**Mangoola Coal Continued operations Project (SSD 8642)**

I refer to your e-mail dated 15 July 2019 requesting advice from the Biodiversity and Conservation Division (BCD) of the Department of Planning, Industry and Environment on the proposed Mangoola Coal Continued Operations Project (SSD 8642). We have reviewed the Environmental Impact Statement and relevant appendices for the project in relation to Aboriginal cultural heritage, flood risk and biodiversity issues in the proposed development footprint.

## Mangoola Coal Continued Operations Project (SSD 8642)

## Biodiversity and Conservation Division's detailed comments

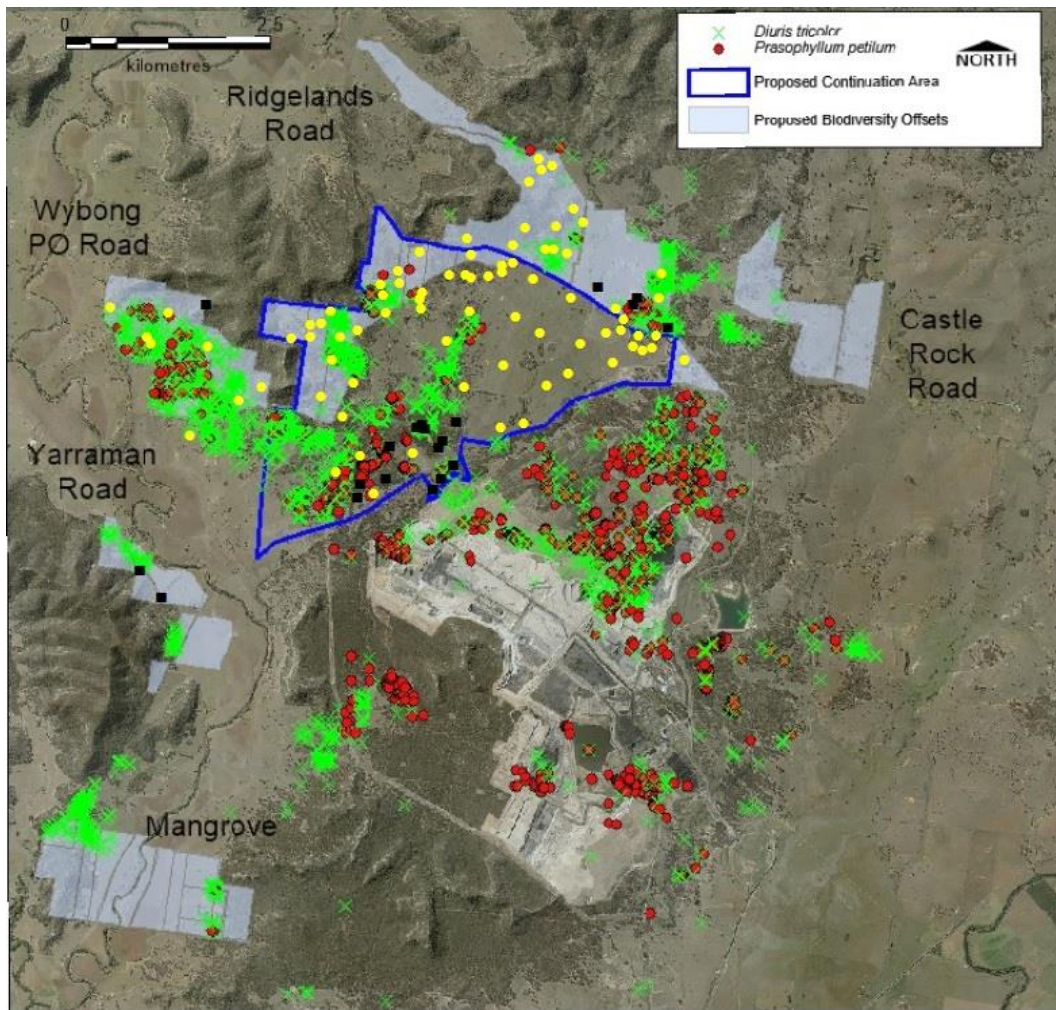
The Expert has identified ten of 14 vegetation communities in the proposed development footprint and Mangoola offset that have the potential to provide habitat for *Diuris tricolor* and *Prasophyllum petilum* (Table 3 in the Expert Report). The Expert identified the 14 vegetation communities from his analysis of the vegetation across the site and then applied his expert knowledge of the two species to nominate 10 of the 14 vegetation communities as orchid habitat. However, when the location of vegetation quadrats of deemed suitable orchid habitat (Figure 18 in the Expert Report) is superimposed over a map of orchid records (Figure 9 in the Expert Report: See **Figure 1** (below)) there is a large number of quadrats where orchids have not been recorded that are identified as orchid habitat.

The Expert used the 10 vegetation communities of orchid habitat as one of the contributing factors during the identification of low, moderate and high quality orchid habitat areas across

the offset sites. We recommend that the suitability of the 10 vegetation communities as orchid habitat is reassessed and that the subsequent estimated number of orchids across the offset areas is reviewed.

**Figure 1.** Combination of Figure 9 (*Diuris tricolor* and *Prasophyllum petilum* records) and Figure 18 (quadrats used for orchid habitat analysis: black squares = not orchid habitat, and yellow dots = orchid habitat) from the Expert Report. The correlation between deemed suitable habitat and orchid records does not appear strong in the eastern and northern part of the development footprint.

The suitability of the 10 vegetation communities identified as orchid habitat by the Expert be reassessed and that the subsequent estimated number of orchids across the offset areas is reviewed.

**Figure 2.** Generalised areas of cultivation or heavy grazing mapped as low-quality habitat (four pale blue polygons) and medium quality habitat (six green polygons) superimposed on a copy of Figure 9 from the Expert Report.

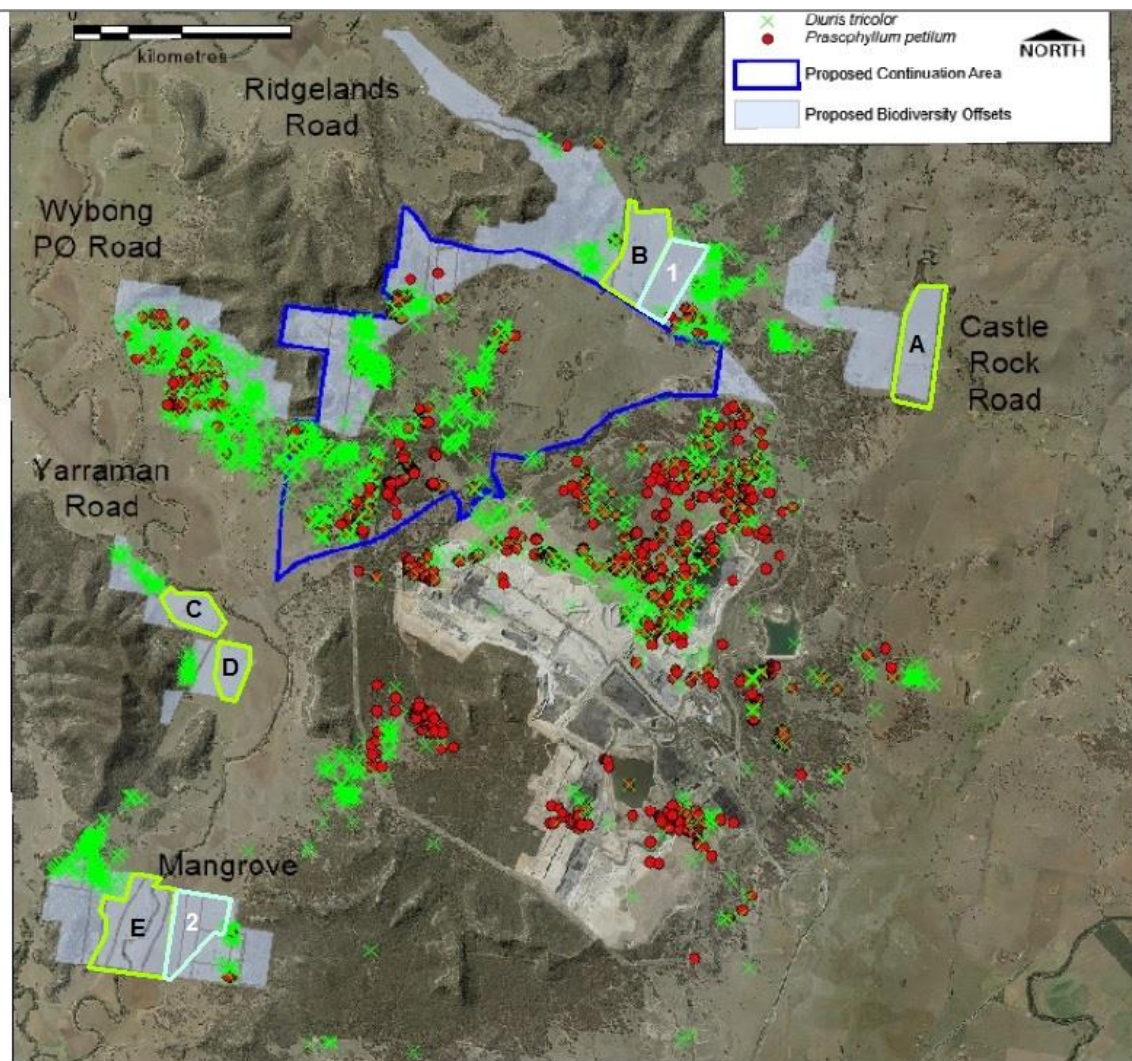
It is unclear why seven areas with a history of cultivation were mapped as 'moderate quality habitat' and 'low quality habitat' (Figure 22 in the Expert Report) where targeted surveys (Figure 10 in the Expert Report) did not find any orchids. These areas are shown in **Figure 2** (below) and comprise five green polygons of 'low quality habitat' (labelled 'A' to 'E') and two pale blue polygons of 'medium quality habitat' (labelled '1' and '2').

Further information to be provided on how the seven areas shown in Figure 2 of the Expert Report were determined to be 'moderate quality habitat' or 'low quality habitat' and why they are not considered to be unsuitable habitat. This includes demonstrating that those areas have not been cultivated in the past, using historic aerial photos and land management records. A preliminary review of aerial photographs suggests that each of the areas could have some level of cultivation history. Any areas revised as 'no orchid habitat' should be excluded from the estimation of orchid numbers in the offset lands. Areas of house paddocks, dams and other waterbodies should also be excluded from the calculation of orchids across all offset lands.

Further information be provided on the cultivation history of the seven polygons in Figure 2 of the Expert Report which were determined to be 'moderate quality habitat' or 'low quality habitat' and justification for why they are not considered to be unsuitable habitat. House paddocks and waterbodies should also to be excluded from the estimation of orchid habitat areas in the offset lands.
